Technical Service Bulletin

TSB#: 215

Title: EXPOBAR Line and FMU Flowmeter Change by Supplier

Affected Parts:

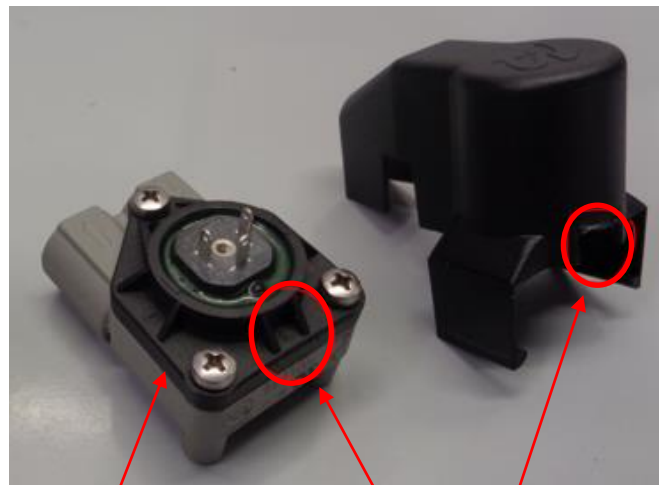
Change description: The supplier of this core component has slightly modified their design to change the top cover of the standard flowmeter used across the entire Expobar line and in the FMU variants. The change is in material and shape, from brass to plastic, and after testing no functional differences are found. The only other issue that is created is that the plastic protection cover will not snap onto the new plastic top cover, however this is not a safety issue, so the plastic protection covers will be deleted from the machines.

**Old flowmeter
design (no
longer in use).**

**New flowmeter
design.**

**Conflict areas
preventing cover (no
longer to be used) and
flowmeter from being
compatible.**
